THE GATHERINGS

SUMMARY

Proposed Signage

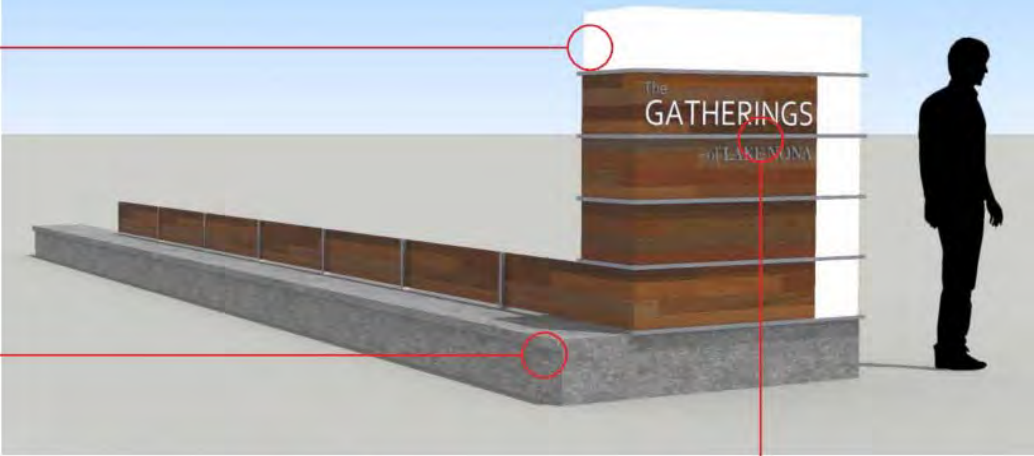
A rendering of the proposed monument sign was submitted with this application (See Page). The proposed signage shall be consistent with Chapter 64 of the LDC and the Lake Nona Master Sign Plan.

The proposed signage shall be consistent with Chapter 64 of the LDC and the Lake Nona Master Sign Plan.

DEVELOPMENT PLAN

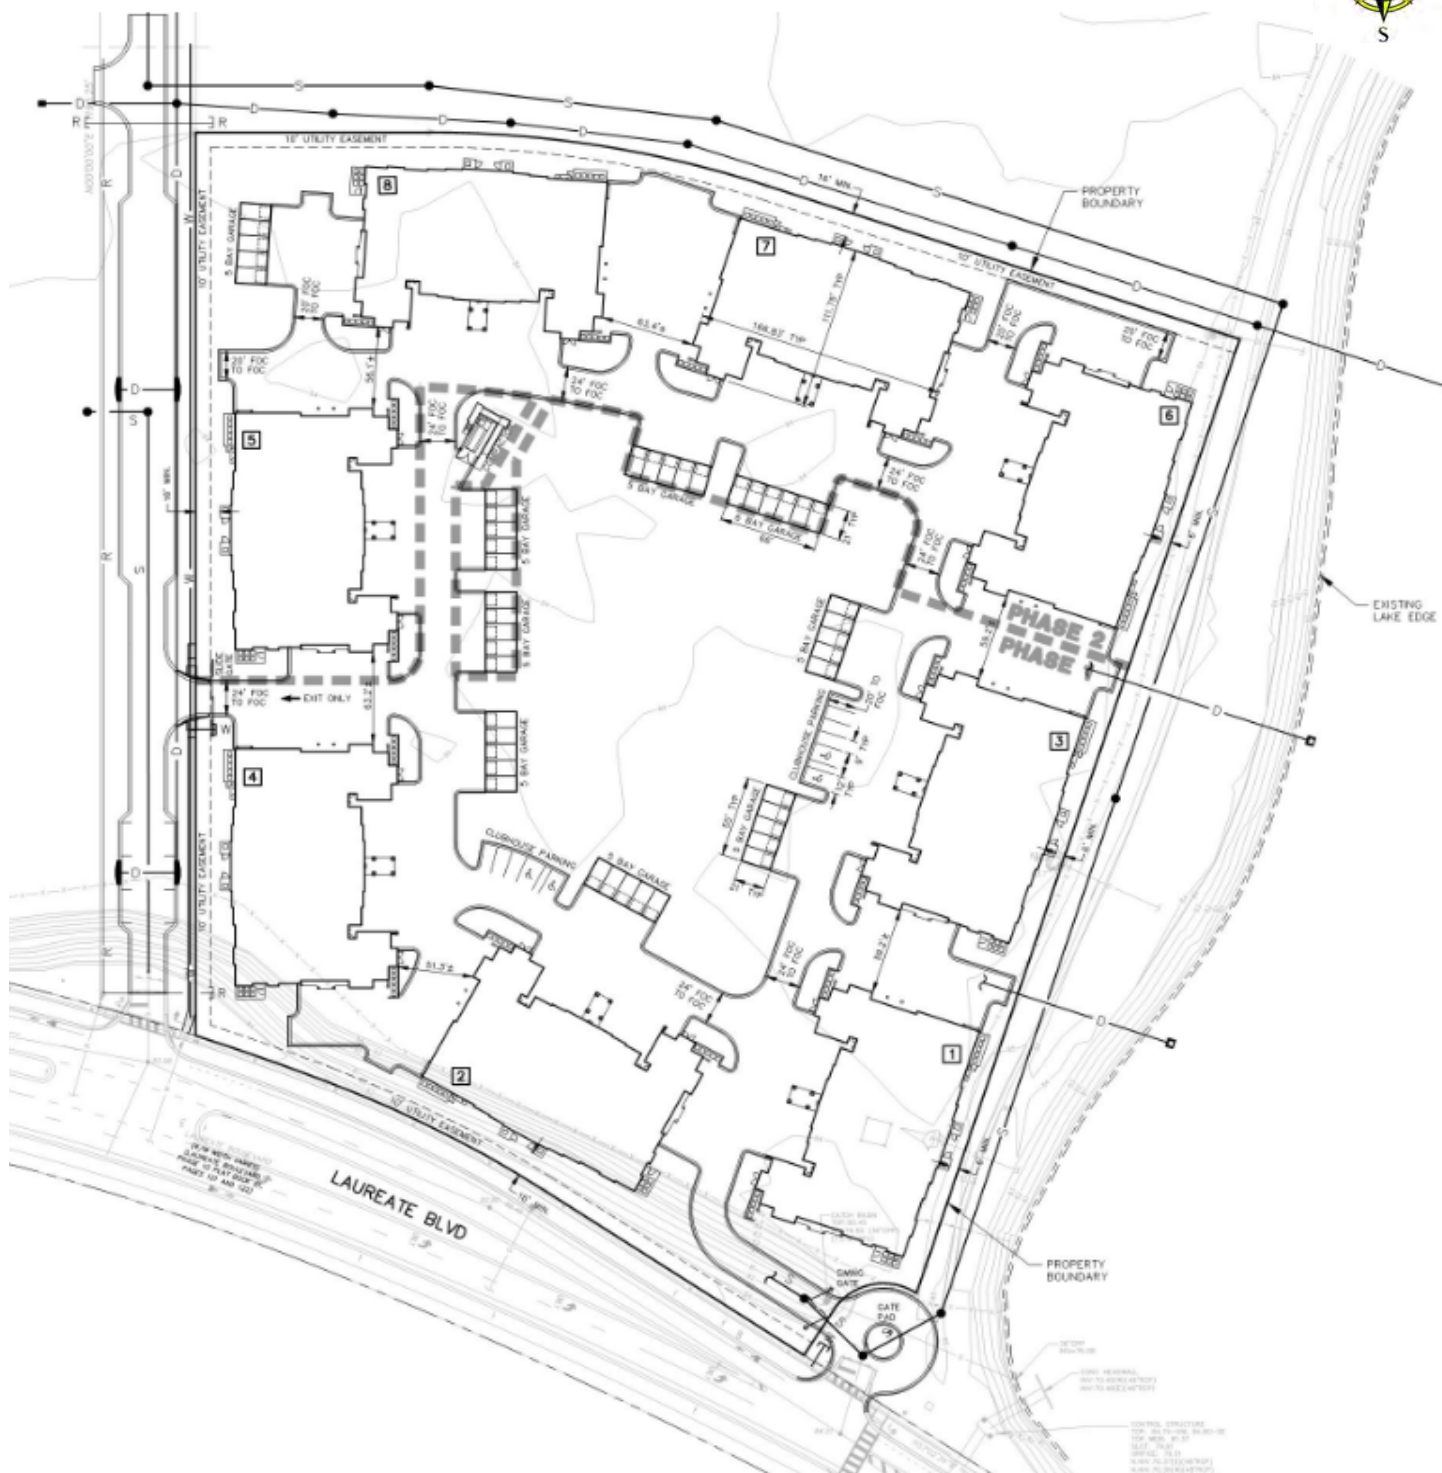
1. The project is in need of a second point of ingress. It is suggested that a second connection could be added to the future street along the northern boundary of the site, provided Building 8 moves further west and the garage at the corner are reconfigured. Or, delete the gating system and provide more even distribution of access.

2. Provide a minimum 4-ft wall and generous landscaping (minimum 36" hedge at time of planting) to screen mechanical equipment locations.
3. There are concerns there is not enough visitor parking provided in this plan. On-Street and unassigned visitor parking should consist of approximately 10% of the parking requirement - please clarify locations of visitor parking and consider additional parking.

3. The entrance shall be relocated to the north/south road on the west perimeter of the site.
4. Minimum drive aisle width shall be 24 feet.
5. Sidewalks adjacent to drive aisles shall be a minimum 6 feet wide and shall be separated by the drive aisle with a curb.

9. The overall site plan and cross sections do not provide sufficient information for review, more dimensions and a clearer layout will be required.
10. Shift the entrance off of Laureate Blvd due to the conflicts at the drop lane. Staff suggests Providing an entrance and exit, possibly separate, from the west side of the property.

CONCEPTUAL LANDSCAPE PLAN

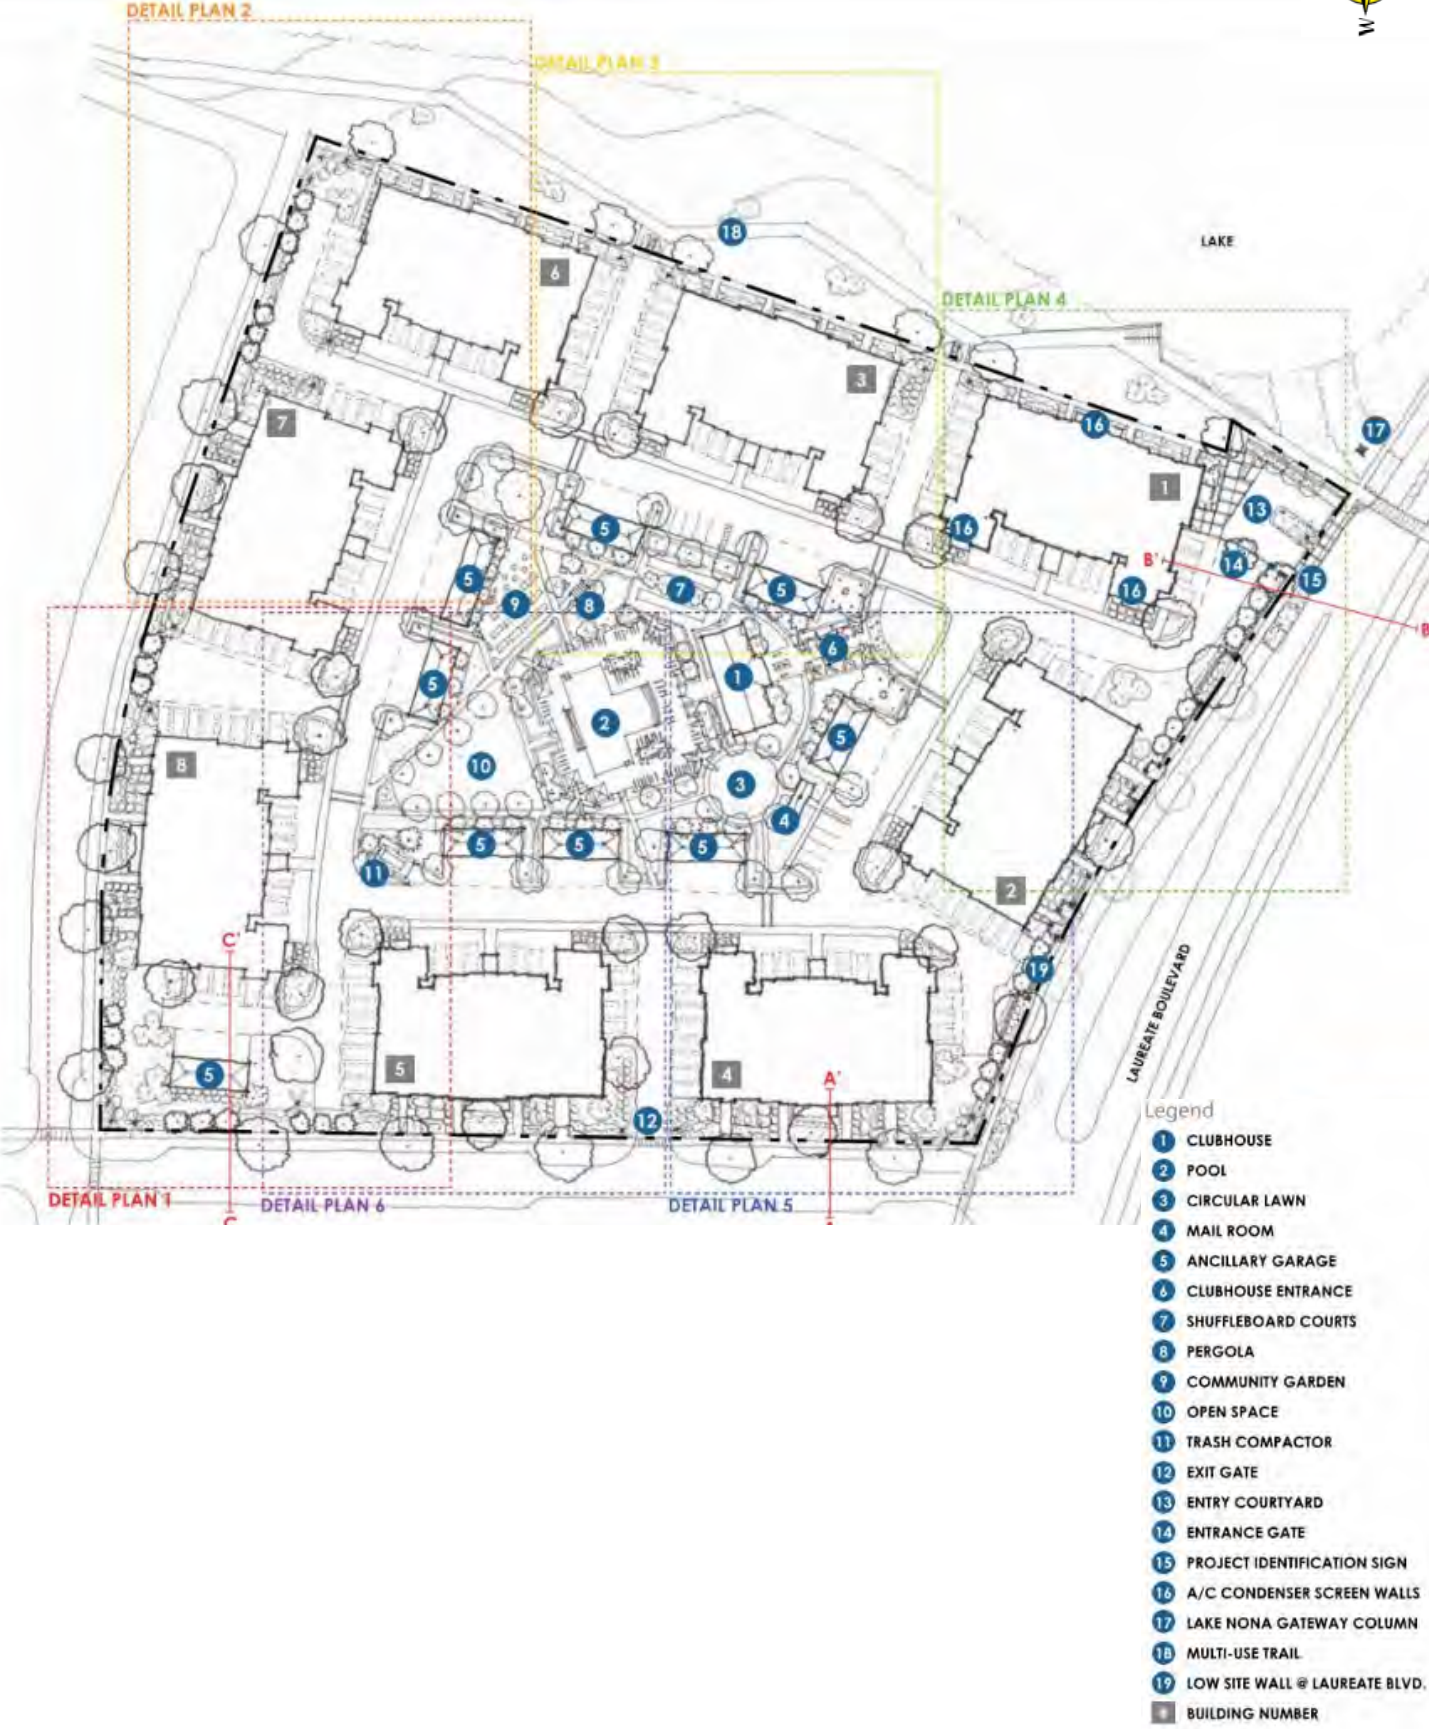
The applicant submitted a conceptual landscape plan with this application. It is noted that the landscape plan will be developed in accordance with Chapter 60. The applicant has also indicated that the landscape plan will utilize the plant palette already established throughout Lake Nona.

The landscaping plan shall be developed in accordance with LDC Chapter 60. A final landscape plan, including plant list, shall be submitted for Appearance Review prior to building permits. The landscape plan shall include the trail and park to the east, and the cul-de-sac to the north.
